**NUCLEAR REACTOR LABORATORY**  
AN INTERDEPARTMENTAL CENTER OF  
MASSACHUSETTS INSTITUTE OF TECHNOLOGY

20 April 2018

Subject: Response to Follow-Up Request for Additional Information for the License Amendment Request to Upgrade the Nuclear Safety System at the MIT Reactor, License R-37, Docket No. 50-20 (CAC No. MF5003)

Photo 1 – NIM Bin 2

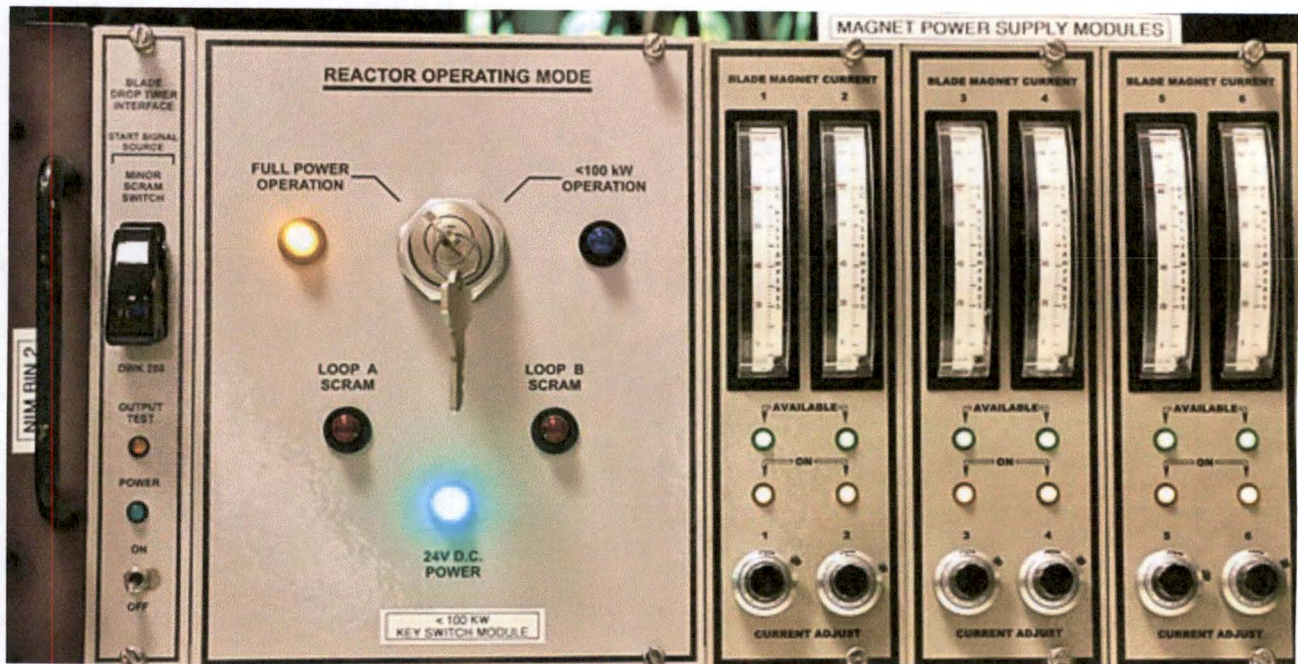
4- In Enclosure D, MIT described the Signal Distribution Module (SDM). This description states that the <100 kW key switch module (KSM) is in NIM BIN 1 and receives power through the X14 connector. However, Enclosure D1 provided the Global Connection Diagram for the NSS, and this drawing does not show the KSM in NIM BIN 1, but instead installed in NIM BIN 2. Please confirm the location of the KSM and the components installed in each NIM BIN.

It is the drawing [Enclosure D drawing R3W-268-2 "NSS Global Connection Diagram"] that is correct. – As shown in Photo 1 below, the KSM is in NIM Bin 2, along with the three Magnet Power Supply Modules and the Blade Drop Timer Interface. It receives power through the X17 connector. The description in Enclosure D [Q/A File document #2017-34 "Signal Distribution Module"] was incorrect in item 5 on page 2. The updated document, now dated 15 March 2018, is enclosed. The correction reads as:

The X14 connector then passes the 24-volt DC power as output to the "NIM Bin 1" instrument rack which contains three downstream components: Scram Logic Card 1, Scram Logic Card 2, and the *LED Scram Display Module*.
